HABERDASHER'S SCHOOL Job No: 9756-1 9756-1 P(0)1001 May 2021 1:50 & 1:20 @A3 Checked: GQ NCB 7 BISHOP'S TERRACE LONDON SE11 4UE GILES QUARME ARCHITECTS
(Chartered Architects)

REVIEW AND DRAFT FOR COMMENT

PLAN WITH REPAIRS/REBUILDING - 1:50@A3

**EXISTING TERRACE STEPS NO.02:**

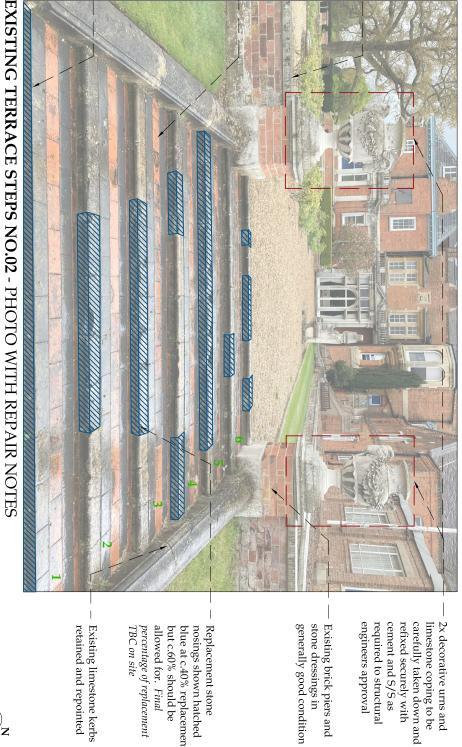
> sections to match and worn. New Stone nosings to treads 02-06 are badly cracked

existing. See marked up

photograph opposite for

extent of replacement

generally in good condition and are to

Existing engineering brick treads are

replaced with new

section to match

not included in works. To be

repointed at a later repaired and and stone copings

Existing low walls

step 01 missing. Stone nosing to bottom

percentage of replacement TBC on site

nosings shown hatched blue at c.40% replacement

Replacement stone

blue engineering and red brick. Mostly in good condition with

alternating courses of

formed from Existing treads are

> repointed be retained and

some bricks requiring replacement with

match from elsewhere

profiles to upper New to match nosing

missing to tread no.1. Limestone nosing 840
